August 18, 2017

Meika Daus, Planner
PWC Planning Office
5 County Complex Court
Prince William, VA 22192

Re: REZ2016-00022, Ray's Regarde
2nd Resubmission and Comment Response Letter

OPEN SPACE & BUFFER PLAN

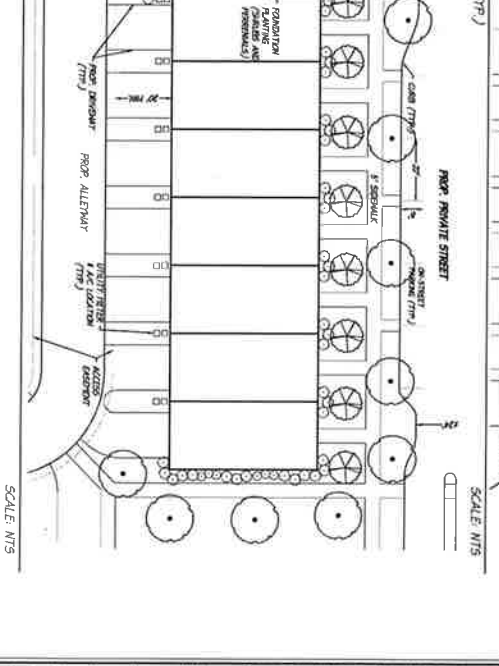
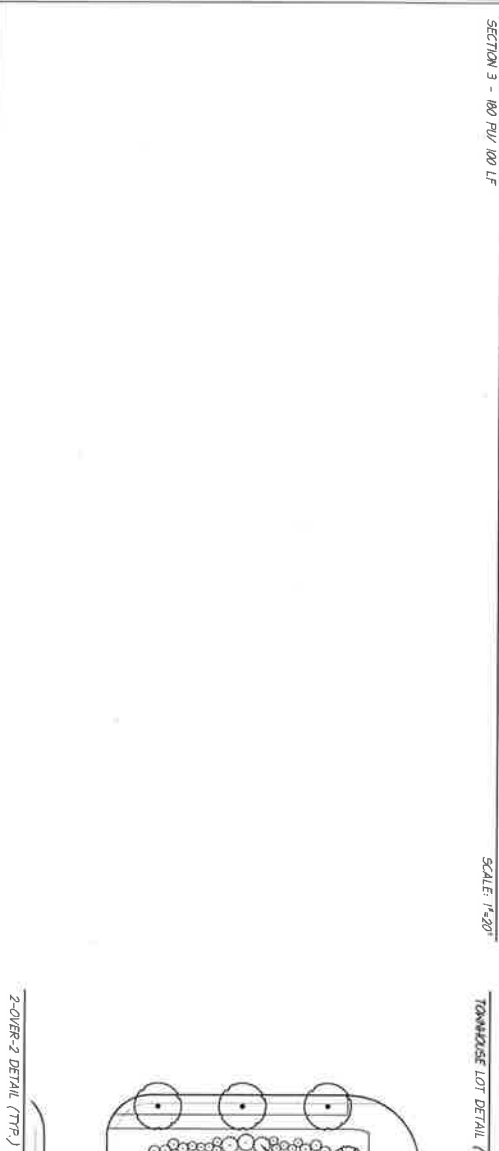
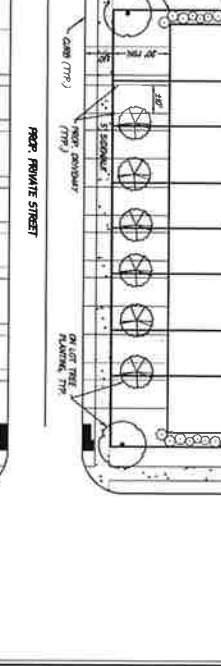
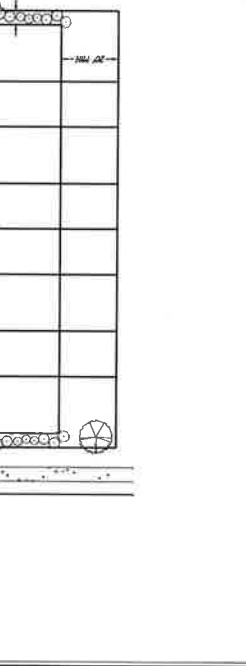
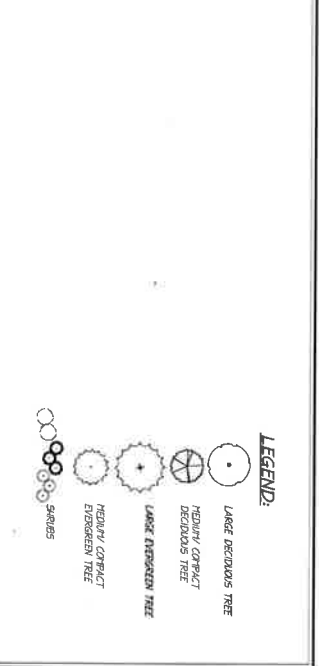
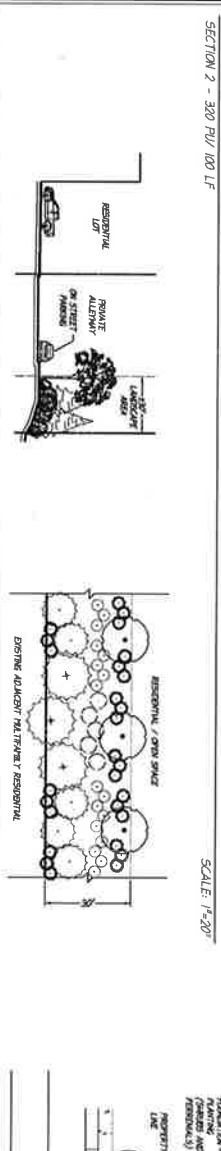
1.4 Regarding the required buffers along I-95, please provide the minimum 75-foot buffer width. <u>DCSM 802.48, Table 8-7</u>	The minimum 75 foot buffer is provided per staff's request. Please see the revised Open Space & Buffer Plan provided with this submission

1.5 Currently all buffers shown within the developed portion of the site are proposed to be cleared. Staff recommends that in areas with existing trees the buffer be left undisturbed (DCSM 802.10.B). For areas without existing trees, please provide an illustrative landscape plan. Preservation and planting within the buffers needs to be addressed in the proffers. DCSM 802.48	The existing topography necessitates grading in buffer areas. Proffers 5, 6 and 10 address planting within buffers. Sheets 3 and 3A of the MZP address landscaping in the buffer areas with details on Sheet 3A. The graded and landscaped buffers will shield adjoining properties from any adverse consequences of development and separate and partially obstruct the views of the abutting land uses.

<p>1.6 What is the reason for the proposed modified buffer along a portion of the boundary with PW Service Authority? The minimum 50-foot buffer should be provided. DCSM 802.11, Table 8-1.</p>	<p>As shown on the revised MZP, the Applicant is providing the full 50' buffer against the PWSA property.</p>
<p>1.7 The Applicant is proposing modifications to the internal use buffers without providing a layout or demonstrating why such modifications are necessary or warranted. Please provide a layout or additional justification for these proposed modifications. Staff recommends that without justification the Applicant provide the minimum required buffering. DCSM 802.11, Table 8-1</p>	<p>The site layout is now provided on the revised MZP and in the Design Guidelines. The Applicant is requesting a modification to the buffer between the single family attached units and the multi-family units. This is being requested to allow flexibility in design and to provide a cohesive streetscape throughout the development.</p>

DATE: 03/23/2016
 DRAWN BY: J. GARDNER
 CHECKED BY: J. GARDNER
 TITLE: TRANSPORTATION IMPROVEMENTS
 PROJECT NO.: 15777
 SHEET NO.: 45

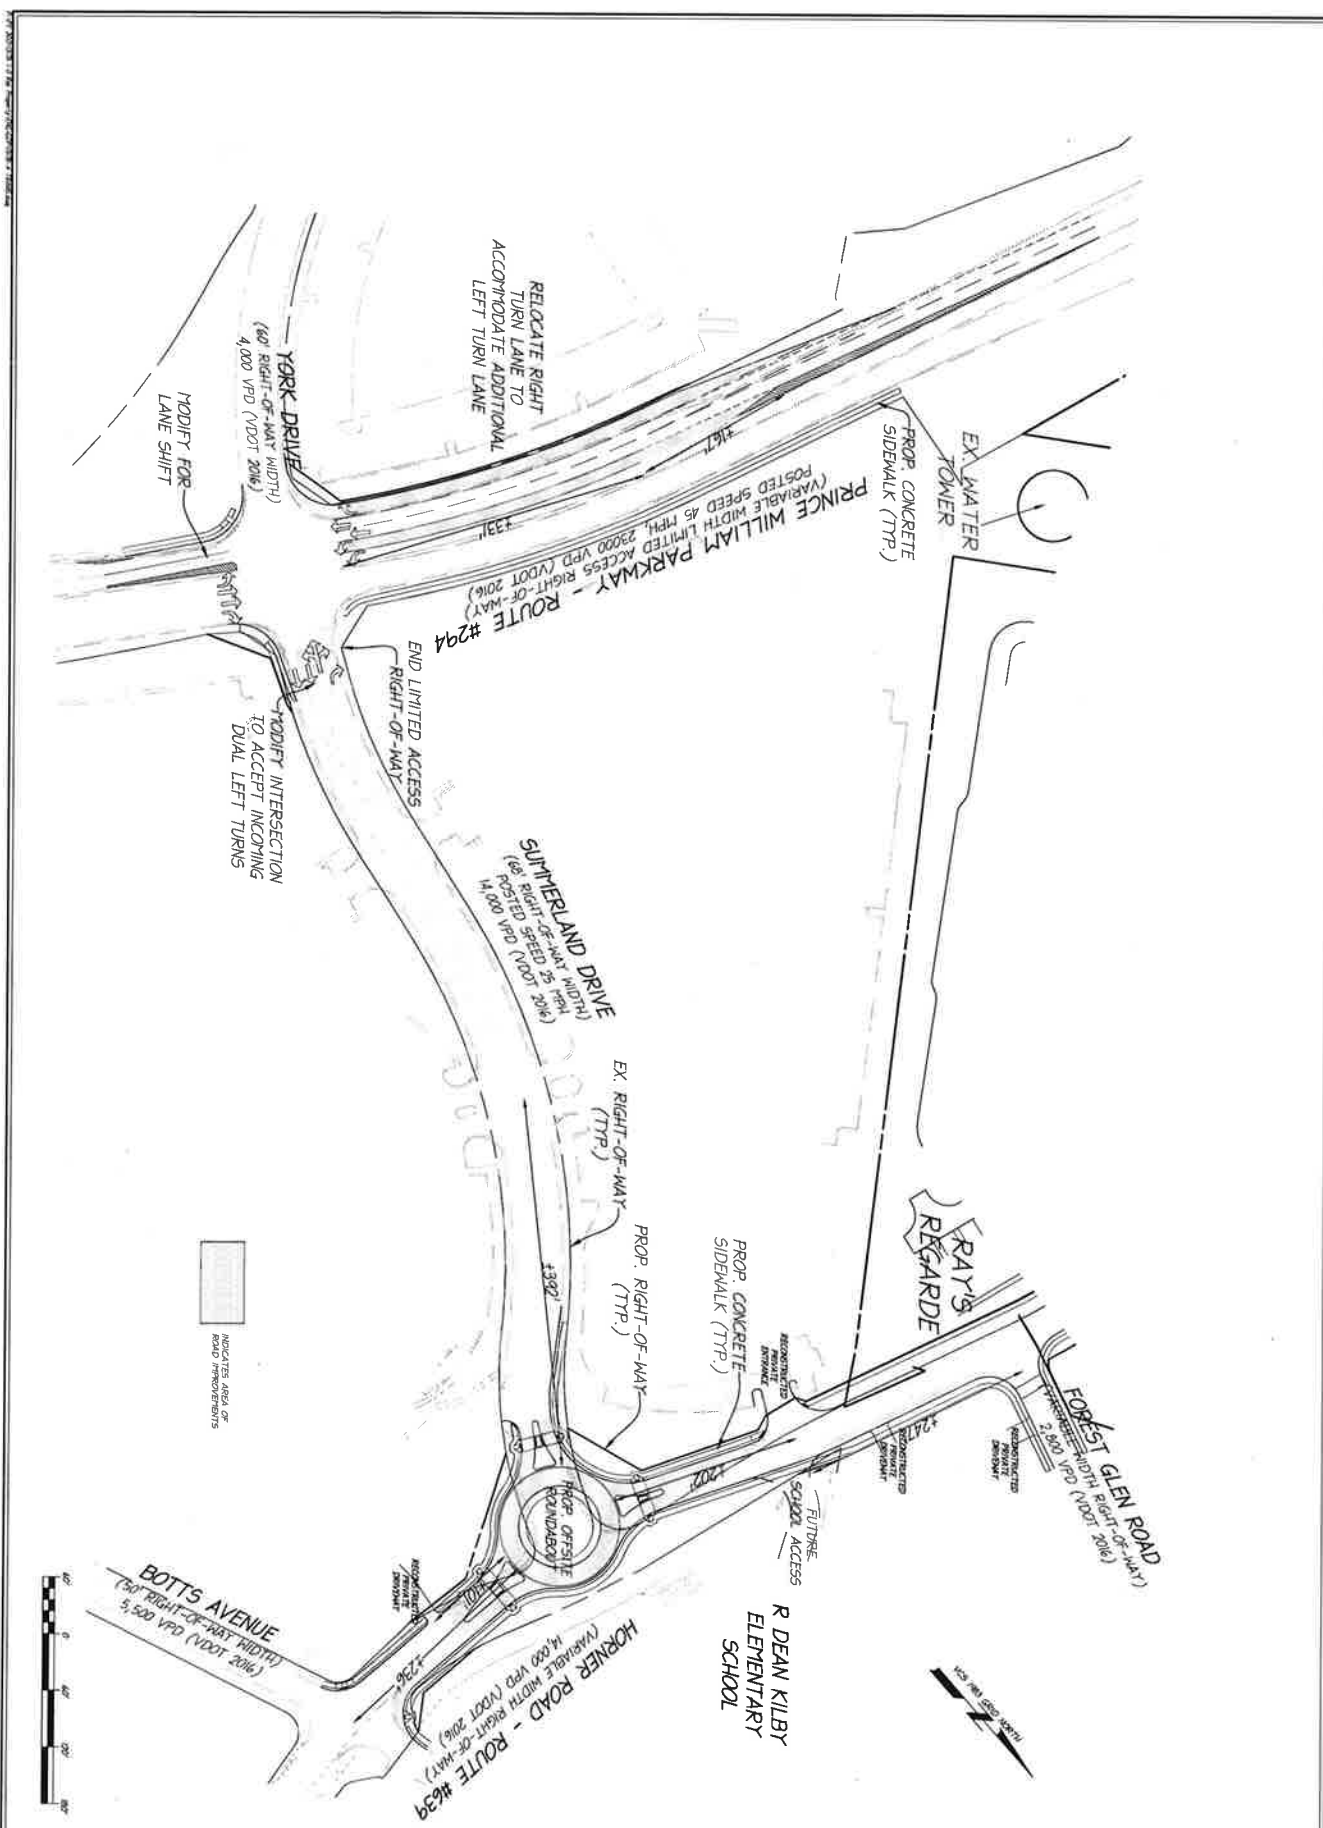
<p>abandoned/realigned. Road Network comprising of private streets should be shown.</p>	<p>Transportation Improvements Plan (Sheet 4 of the MZP), the Applicant will reconstruct four private driveways as a result of the proposed Horner Road improvements.</p> <p>The road network is shown on the MZP.</p>
<p>1.03 Proposed round about at the intersection of Horner Road and Summerland drive needs to be shown on the GDP. All new development access will need to meet the access management standards, regulations and design standards for minor arterials, collectors, and local streets. The design standards govern the design of intersections, turn lanes, roundabouts and entrances as well as providing spacing standards for entrances, intersections, crossovers, and traffic signals on minor arterials, collectors, and local streets. The GDP should show the access management standards and should include a figure detailing the distances between the driveways as well as existing and proposed intersections.</p>	<p>Comment noted. Please see Sheet 4 of the revised MZP, entitled "Off-Site Transportation improvements," which shows the Horner Road/ Summerland Drive roundabout. As requested by staff, access management standards have been added.</p>

<p>1.04 It appears from the traffic analysis, that significant transportation improvements will be required for PW Parkway at its intersection with Summerland Drive. Such improvements should be recommended in the TIA, shown on the GDP and made be part of the proffers for the rezoning.</p>	<p>Comment noted. Improvements on Prince William Parkway are shown on Sheet 4 of the revised MZP, entitled "Off-Site Transportation Improvements". As noted above, the Applicant is providing a second left turn lane, (creating a dual left onto Summerland), as well as extending the turn lanes on Prince William Parkway for more queuing capacity. These improvements are shown in the TIA as recommended mitigation measures.</p>
<p>1.05 Project clearing and grading of the development should be completely clear of limited access right of way for I-95 and PW Parkway. Clearly show the limited access boundaries on the GDP.</p>	<p>The limited access right of way is clearly identified on Sheet 4 of the MZP.</p>
